Rezoning Transportation Analysis

Petition Number: 2017-166

Revision Log:

Date	Description
11-20-2017	First Review

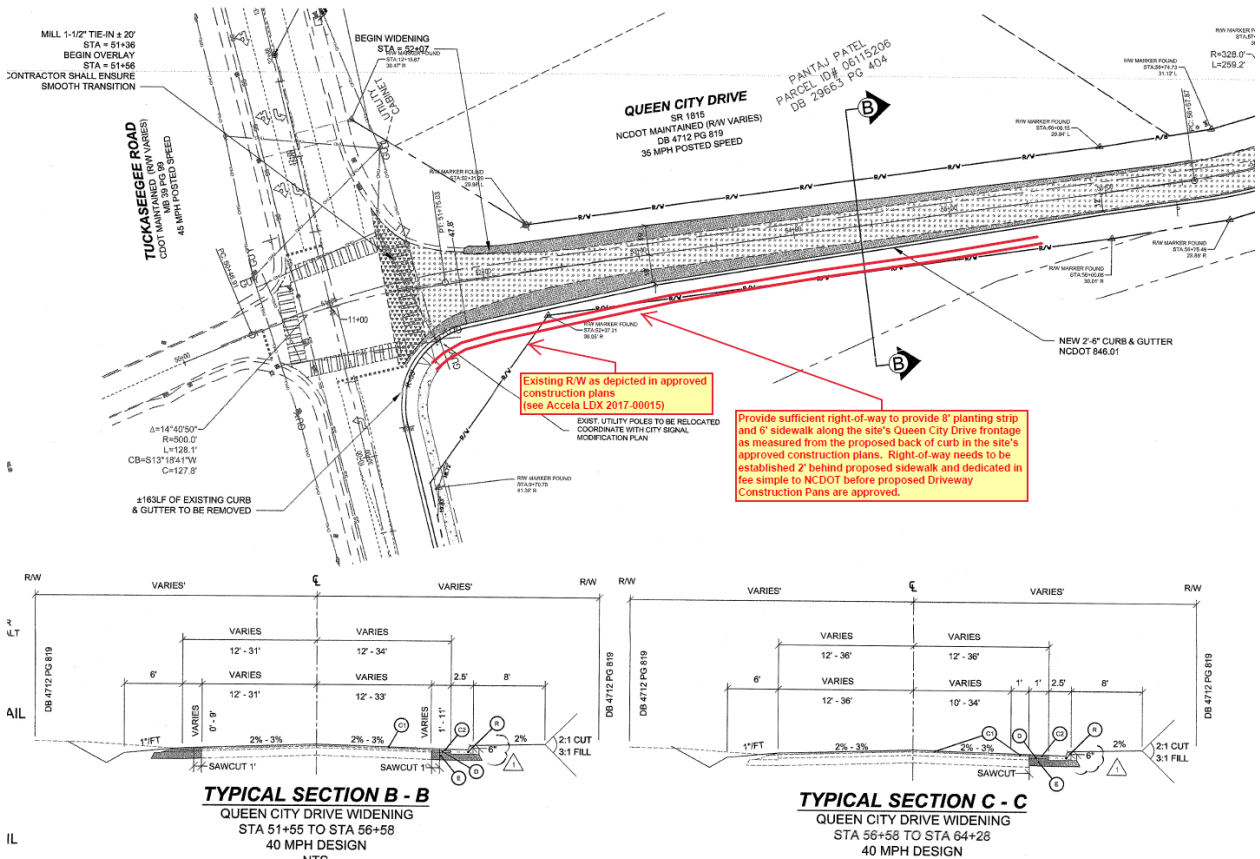
- ~~Traffic Impact Study/Transportation Technical Memorandum is not needed for the complete review of this petition.~~
- The petitioner should revise the site plan and conditional note(s) to provide sufficient right-of-way and implement an 8' planting strip and 6' sidewalk along the site's Queen City Drive frontage as measured from the proposed back of curb as shown in the site's approved construction plans (see Accela Project No. LDX-2017-00015 approved construction plans below). Right-of-way needs to be established 2' behind proposed sidewalk and dedicated in fee simple to NCDOT before proposed driveway Construction Plans are approved.

3. The petitioner should revise the site plan to add a note specifying dedication and fee simple conveyance of all rights of way to the City before the site's proposed driveway construction plans are approved by CDOT. CDOT requests right of way set at 2' behind back of sidewalk where feasible.
4. The petitioner should revise the site plan to add a note specifying all transportation improvements will be approved and constructed before the site's first building certificate of occupancy is issued. The petitioner may phase transportation improvements if said improvements and phasing are explicitly described in site plan notes.
